Addendum No. 5

Reference: George S. Eccles Student Life Center
University of Utah – Salt Lake City, Utah
DFCM Project No. 08015750

Addendum No. 3 Issued: 06/11/13

Addendum No. Three
for the
Student Life Center
Bid Package
MHTN Project No. 2010562

SHEET REFERENCE
D4/AE552

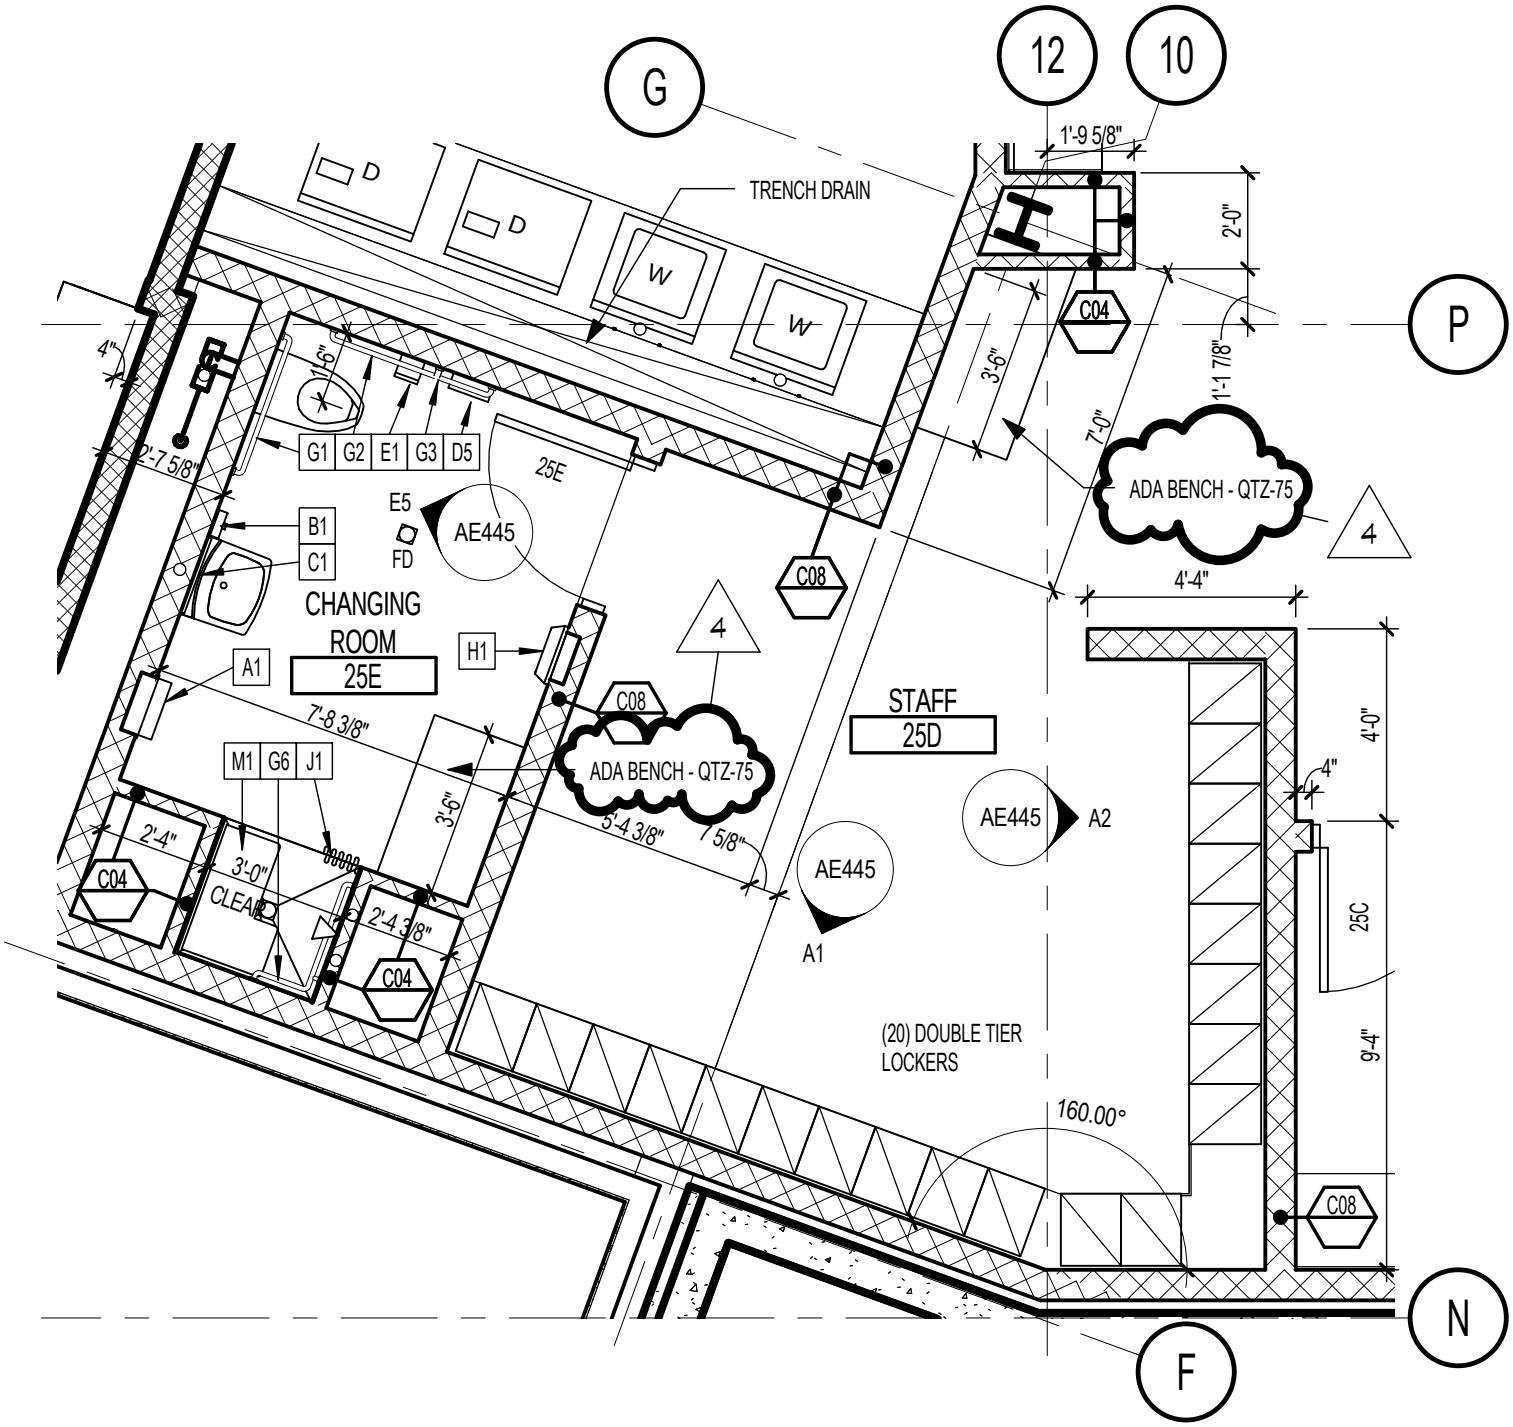
A4.58 Sheet AE552 D4

1. Add standard coat hook detail. AD004-AE001

1 ES100.5 ENLARGED ELECTRICAL TUNNEL PLAN

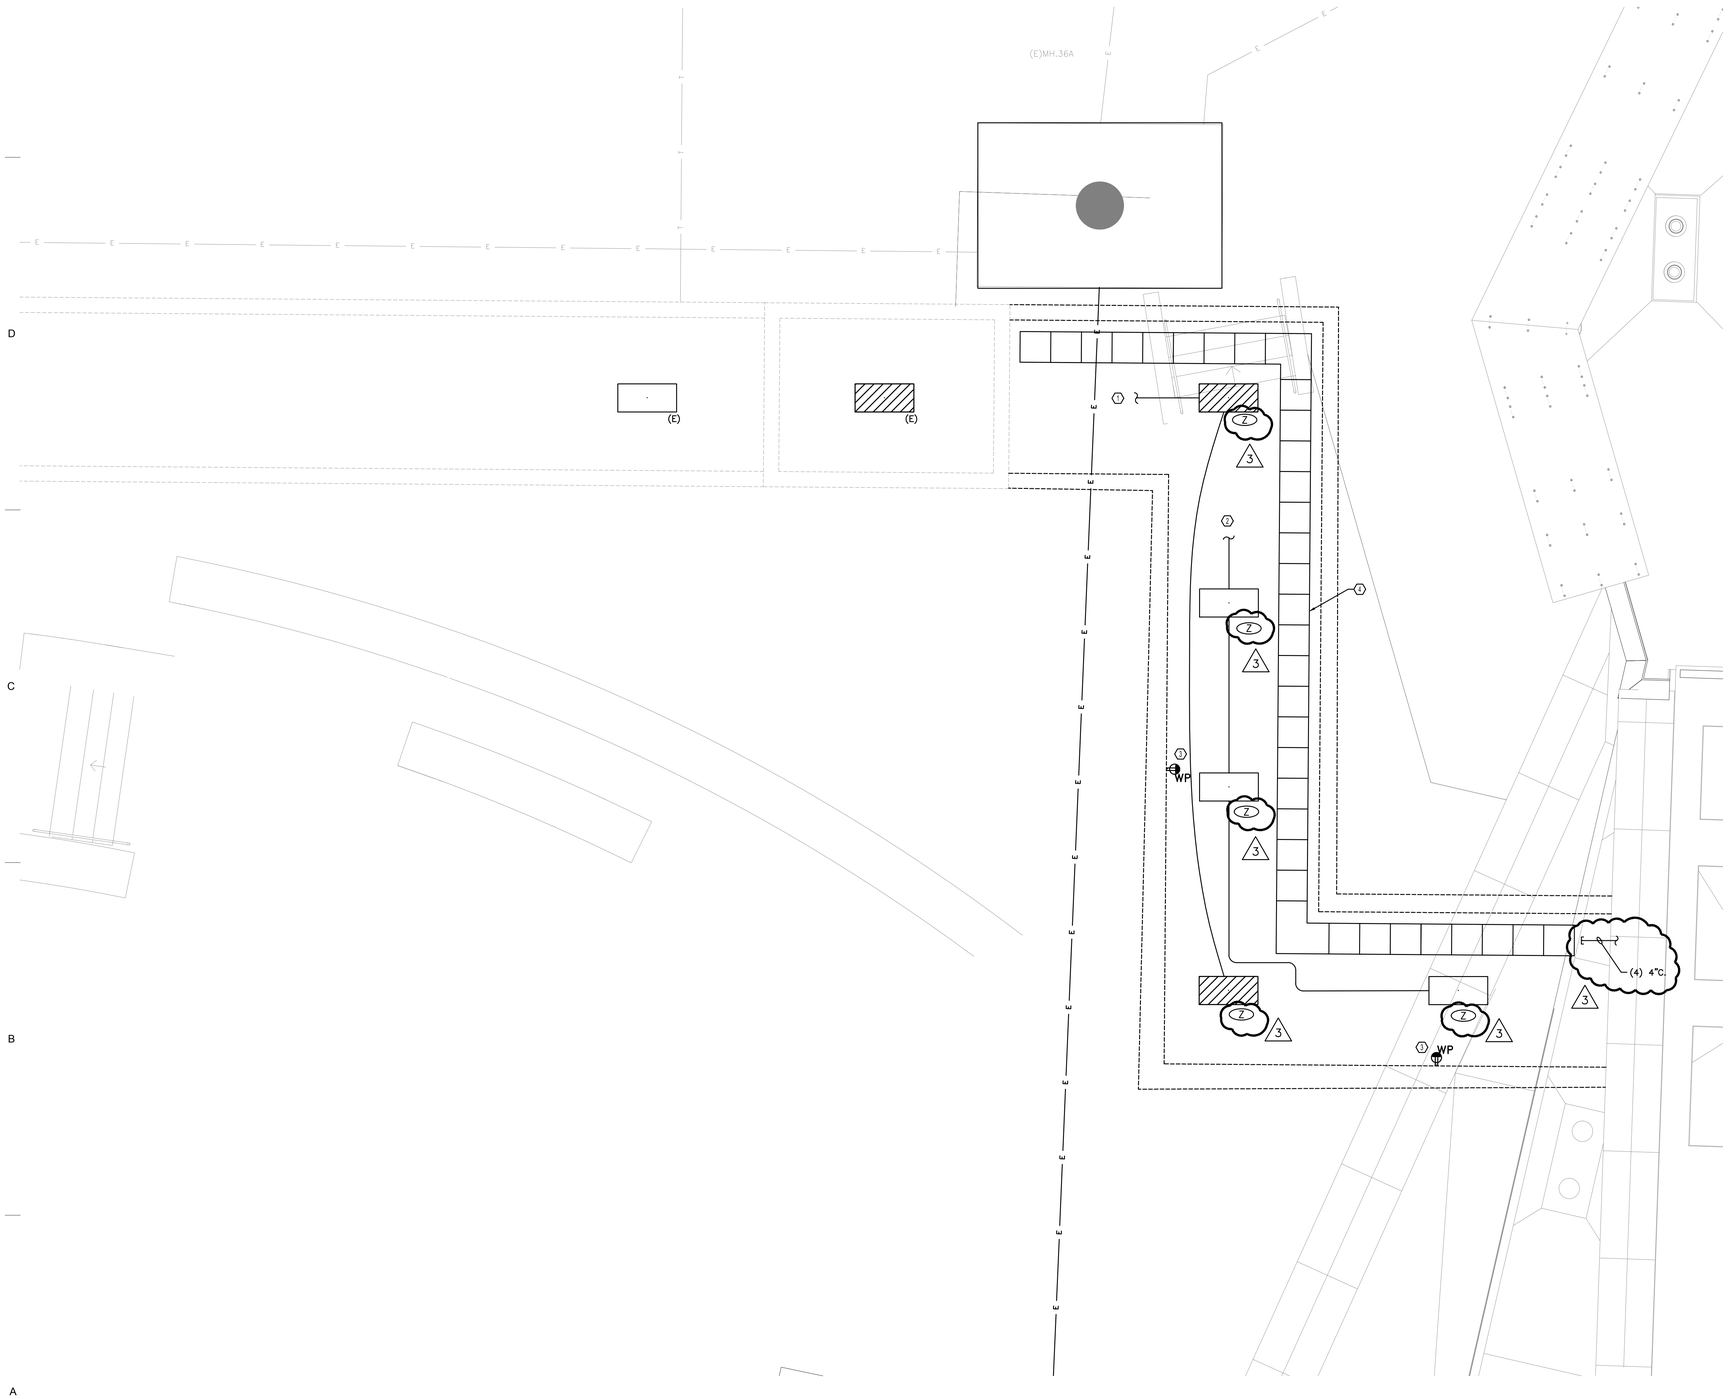
A4.86 Sheet ES100.5 – Enlarged Electrical Tunnel Plan

1. Add: Lighting fixtures in tunnel shall be type 'Z'.
2. Clarification: Tunnel cable tray ends at building foundation. Provide (4) 4" conduit from cable tray to stub up into main MDF room in lower level. See sheet EP501 for stub locations. (1) 4"C shall be innerduct and (3) for communication.
